Summary of Sign Standard Updates

ITS-030-A/ITS-031-A

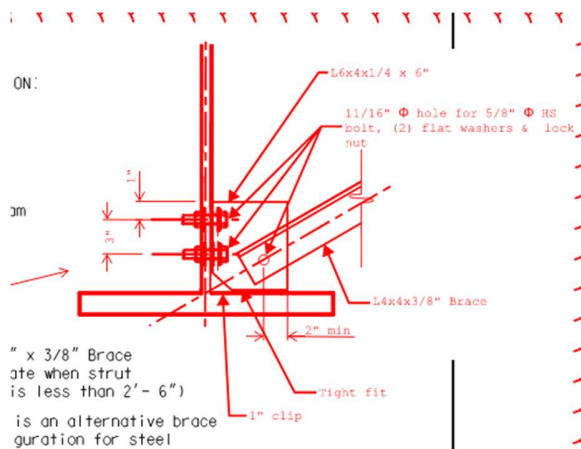
- Added note "Templates may use multiple pieces joined by two-sided complete joint penetration welds, with welds at least 2" clear of rod holes."

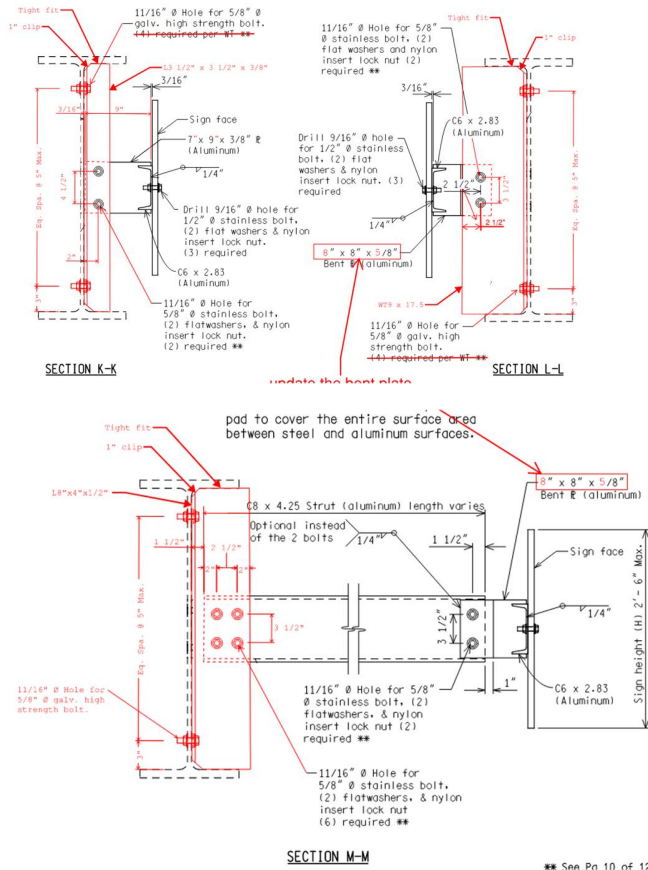
- **All sheets**
 - Removed Date
 - Updated bent plate properties to 8"x8"by5/8"
 - Removed inch marks from weld symbols.
- **Sheet 1 of 12**
 - Moved arrowhead for section callout to point the other way in "Bridge Connection – Type A1" detail.
 - Department director updated from Kimberly Avery to "Bradley C. Wieferrich, P.E"
- **Sheet 2 of 12**
 - Updated alternate connection detail for attachment to steel girder.

- **Sheet 5 of 12**
 - Added "* Stop fillet weld short of corner" note.
- **Sheet 6 of 12**
 - Added "* Stop fillet weld short of corner" note.
 - Added "1" clip" callout to "Section H-H" detail.
- **Sheet 8 of 12**
 - Moved section K cut slightly to the left in "Plan 0 degrees Connection" detail.
 - Added "WT9x17.5" and "L8"x4"x 1/2"" callout to "Plan 5 degrees – 40 degrees Connection" detail.
- **Sheet 9 of 12**
 - Updated "Section K-K", "Section L-L", and "Section M-M" detail to the following.

- **Sheet 11 of 12**

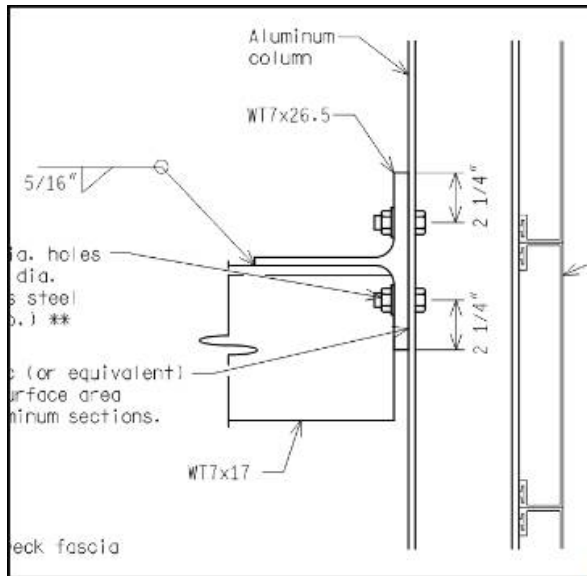
- Removed "current" prior to Standard Specification for Construction
- Added "or grade 50S" after AASHTO M 270 grade 36.
- Updated 707.03 to 707.03.E.6
- In reference to non-shrink grout "702.02.B" updated to "1005.02.B"
